# Access Compliance Report

## Public Rights-of-Way

Intersection ID: 54455	Main Street: COLLINGHAM_DR	Cross Street: RUPELL_DR	Location: SE
ADA ID: 564832658427	Ramp Type: BlendTrans1	Initial Pass/Fail: Fail	Overall Compliance: No
		Severity Score: 10

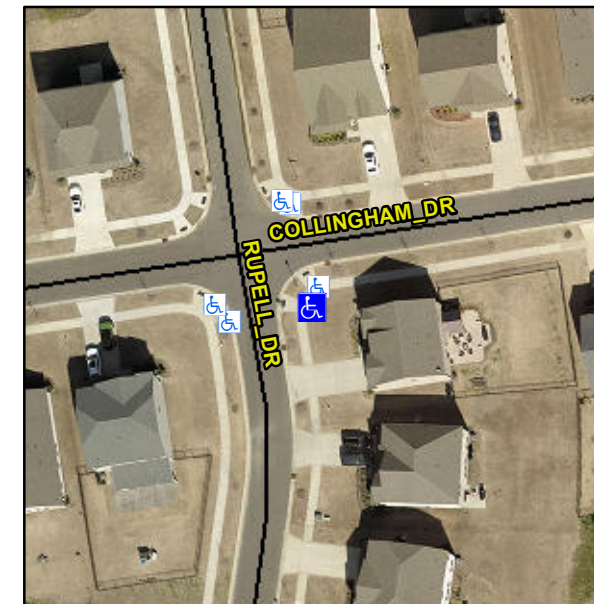
**Not Found, R304.5.1, R304.5.3**

Compliance	Description	Data	Compliance	Description	Data
N/A	Ramp Length (in)	109.0	Yes	BlendTrans Slope (%)	3.5
No	Ramp Width (in)	46.5	No	BlendTrans XSlope (%)	3.8
N/A	Flare Type LT	N/A	N/A	Flare Type RT	N/A
N/A	Flare Slope LT (%)	N/A	N/A	Flare Slope RT (%)	N/A
N/A	Flare Traversable LT?	N/A	N/A	Flare Traversable RT?	N/A
N/A	Landing Length (in)	N/A	N/A	DWS Provided?	N/A
N/A	Landing Width (in)	N/A	N/A	DWS Contrast?	N/A
N/A	Landing Slope (%)	N/A	N/A	DWS Length (in)	N/A
N/A	Landing X Slope (%)	N/A	N/A	DWS Full Width?	N/A
N/A	Landing Curb? (Y/N)	N/A	N/A	DWS Offset (in)	N/A
N/A	Shared Landing?	N/A			
N/A	Gutter Ponding?	N/A	N/A	Gutter Slope (%)	N/A
N/A	Gutter Lip Ht (in)	N/A	N/A	Gutter X Slope (%)	N/A
N/A	Painted X Walk1?	No	N/A	Painted X Walk2?	N/A
	X Walk 1 Direction	To SW		X Walk 2 Direction	N/A
	X Walk 1 Width (in)	N/A		X Walk 2 Width (in)	N/A
	X Walk 1 Slope (%)	1.7		X Walk 2 Slope (%)	N/A
	X Walk 1 X Slope (%)	2.7		X Walk 2 X Slope (%)	N/A

N/A	Ramp inside XWalk1?	N/A	N/A	Ramp inside XWalk2?	N/A
	Road Slope (%)	2.7		Clear Space?	N/A
	Road X Slope (%)	1.7	N/A	Clear Space to XWalk (in)	N/A
N/A	Any Obstructions?	N/A	N/A	Storm Grate/Utility Hazard?	N/A
	Obstruction Type			Storm Grate/Utility Type	
		N/A			N/A
			Yes	Surface Condition? (G/P)	Good
			No	Curb Slope (%)	9.5

**Remove & Replace Curb Ramp With Two New Directional Ramps or Equivalent.**
